UNITED STATES PATENT AND TRADEMARK OFFICE

APPLICATION NO.	FILING DATE	FIRST NAMED INVENTOR	ATTORNEY DOCKET NO.	CONFIRMATION NO.
10/743,458	12/23/2003	Tsuyoshi Kubota	90606.2/wa	8146

Office Action Summary

DETAILED ACTION

Figure 19

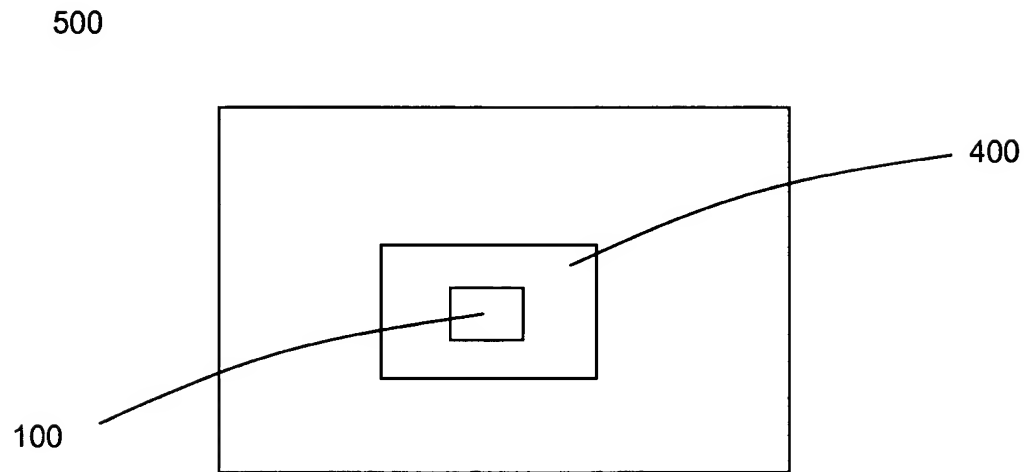
OK to enter, Ch
